Access Compliance Report

Public Rights-of-Way

(Curb Ramps)

Intersection ID: 14078	Main Street: EAST_BV	Cross Street: SOUTH_BV	Location: NW
ADA ID: F62BB29001EC	Ramp Type: BlendTrans2	Initial Pass/Fail: Pass	Overall Compliance: No
			Severity Score: 10.25

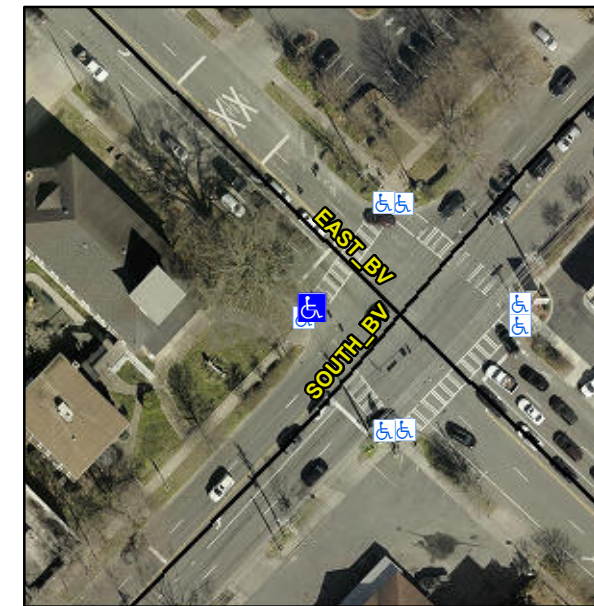
Surveyor Notes:

N/A

Not Found, R304.2.3, R305

Possible Solutions:

Remove & Replace Curb Ramp With Two New Directional Ramps or Equivalent.
